IEEE802.3bt
LLDP adhoc

Meeting #7: Tuesday August 8, 2017
Rev001

- **The purpose** of this ad-hoc is to resolve LLDP state machine related comments from D2.4 and related issues for PSE and PDs prior sponsor ballot for D3.0.

- Argument #3

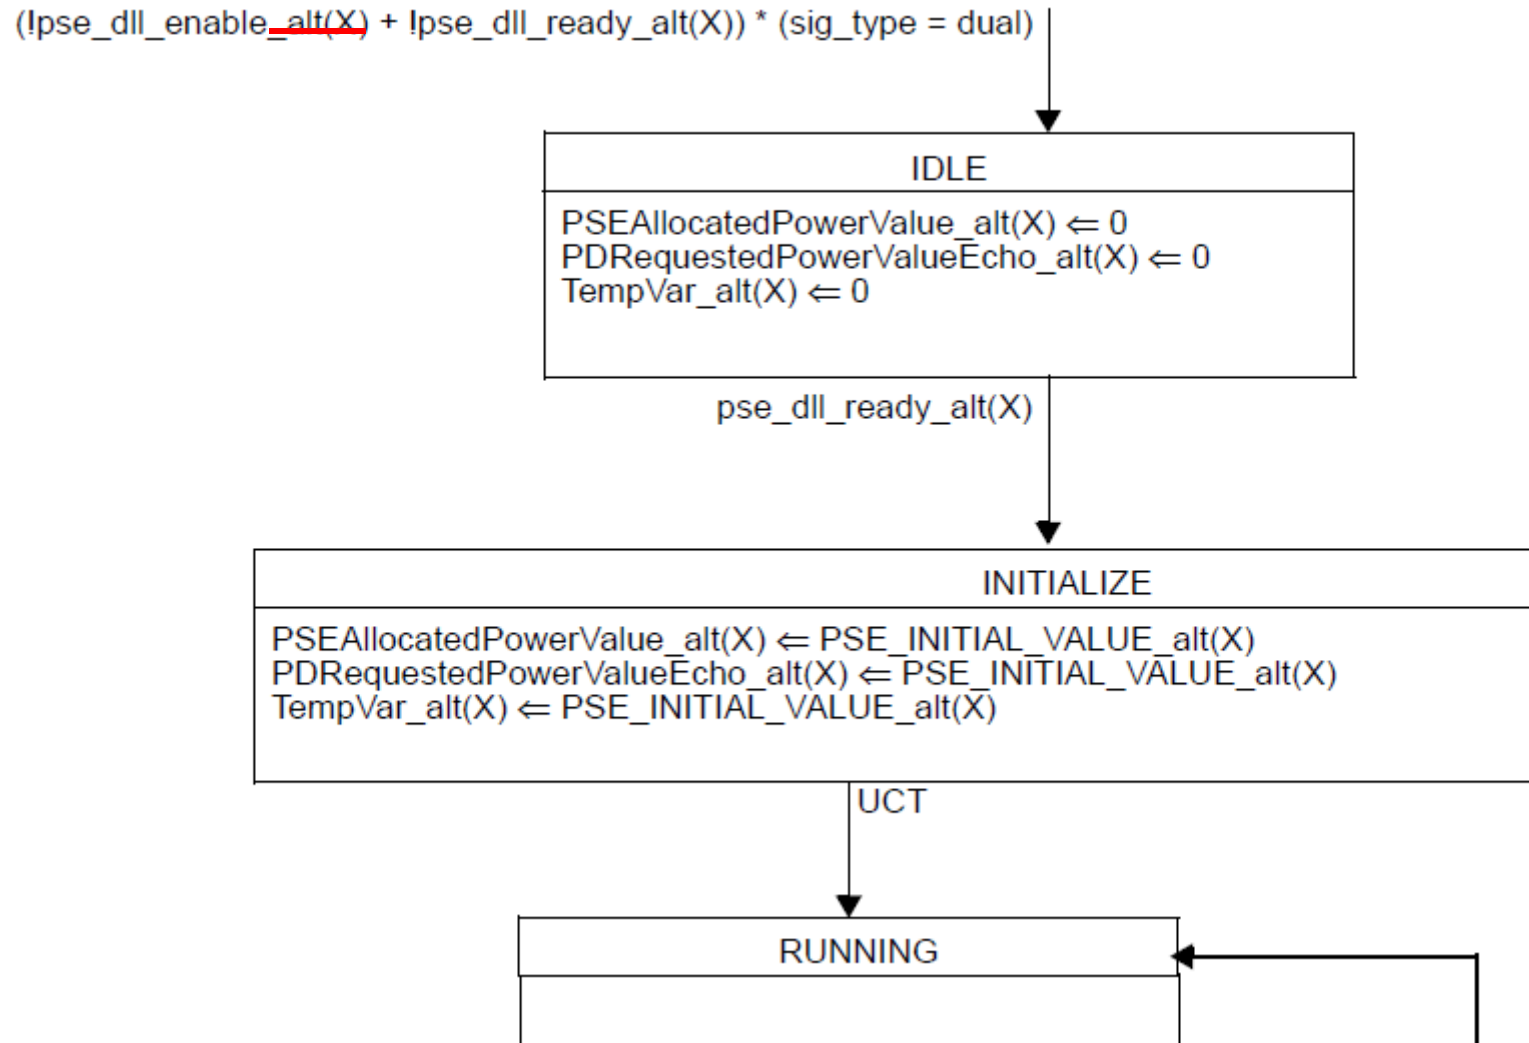
High level power management care only for the total port power. The power management per pairset is kind of sublayer of the power management system. It is useful to pass the total power through the TLVs field. This is in general how current PSEs systems works.

Other alternative solution to this problem is to use the field “PSE max available power” which should be the total port power. We need to clarify in 79.3.2.6e that this value is applicable for PSE that supports single-signature and dual-signature.

Annex B: Comment #297 D2.4 (Page 75 line 12 in D2.5) - Figure 145-43

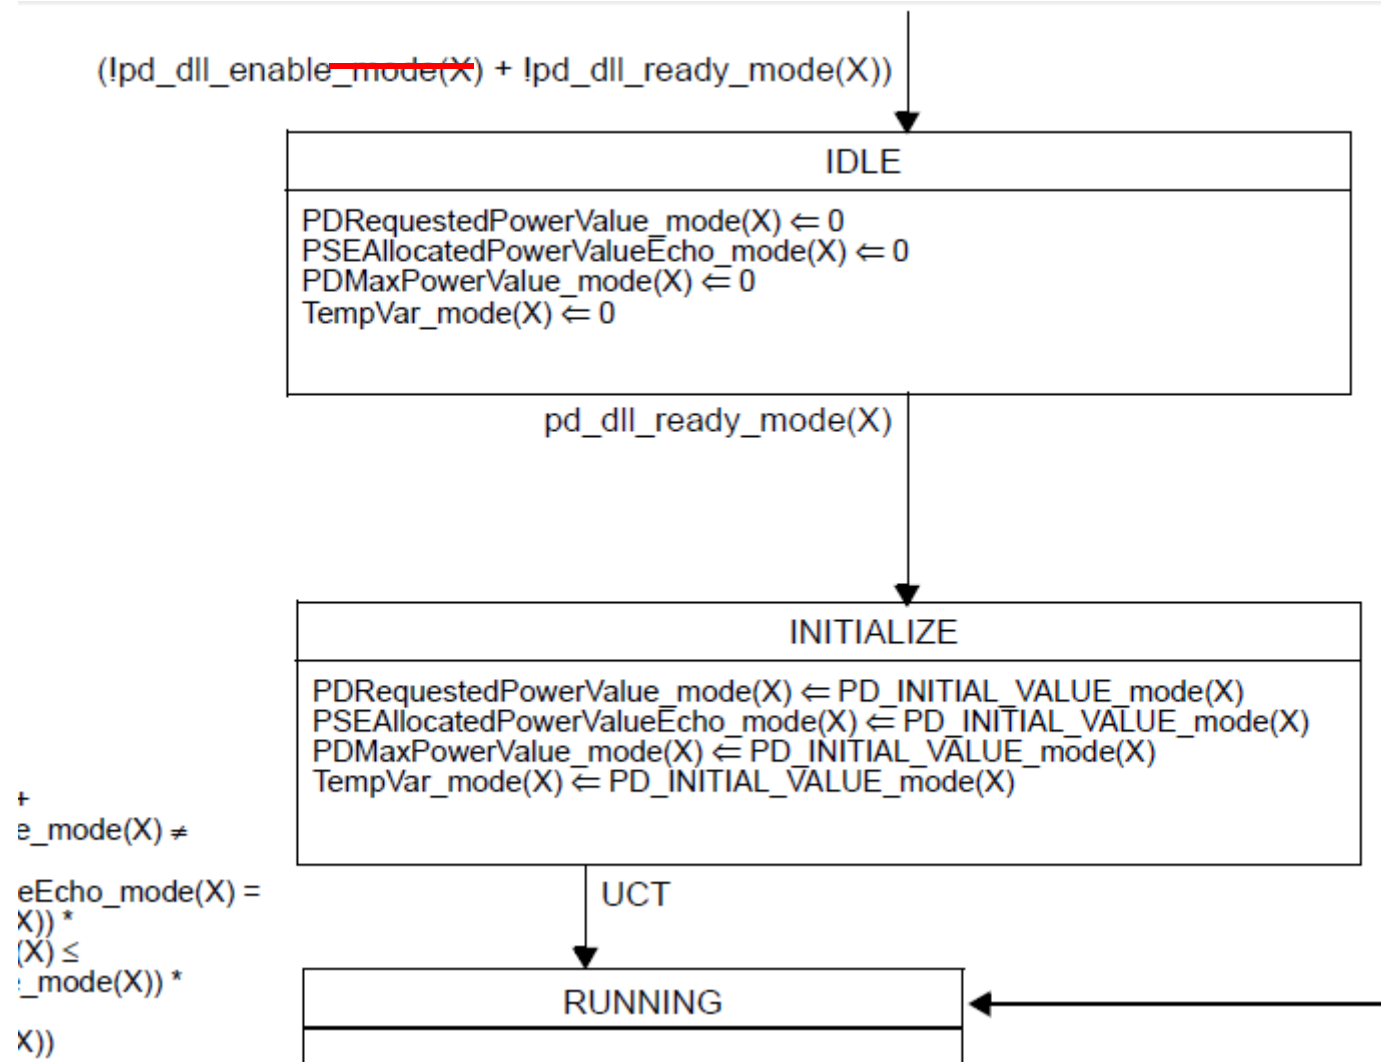
- We have the information of total available power in the field “PSE maximum available power” in 79.3.2.6e. This resolve argument #2 in Annex A.
- To resolve #297, Lennart suggests: In order to request power on the unpowered pairset, see proposed changes in the red text. In addition, the `pd_dll_ready_mode(X)` need to be changed to `pd_dll_ready` to allow progressing to the INITIALIZE state in case PD want power on the unpowered pairset. No changes required in the PSE portion.

- Yair it will work:
- The proposal is:
 - To change from `pd_dll_ready_mode(X)` to `pd_dll_ready` in the PD state machine.
 - To change “if this mode/Alt is inactive, set to value 0” to “if this Alt is inactive, set to value 0” i.e. keep this requirement only to PSE.

- Comment #297 D2.4 (D2.5 Page 78 line 46)

"If Mode (X) is non-active while the other mode is active, the inactive PD requested power value Mode (X) field value shall be set to 0."

- What is this trying to do ? The PD may wish to ask for power on an unpowered Mode...

- Group is OK.

- Lennart response: The proposed response to this comment is to adopt:
 - To change from `pd_dll_ready_mode(X)` to `pd_dll_ready` in the PD state machine.
 - To change “if this mode/Alt is inactive, set to value 0” to “if this Alt is inactive, set to value 0” i.e. keep this requirement only to PSE.
- **Group to discuss.**
- **GROUP OPINION? Group is OK.**
 - The modifications proposed to the state machine in Figure 145-43?
 - To change from `pd_dll_ready_mode(X)` to `pd_dll_ready` in the PD state machine.
 - To change “if this mode/Alt is inactive, set to value 0” to “if this Alt is inactive, set to value 0” i.e. keep this requirement only to PSE.
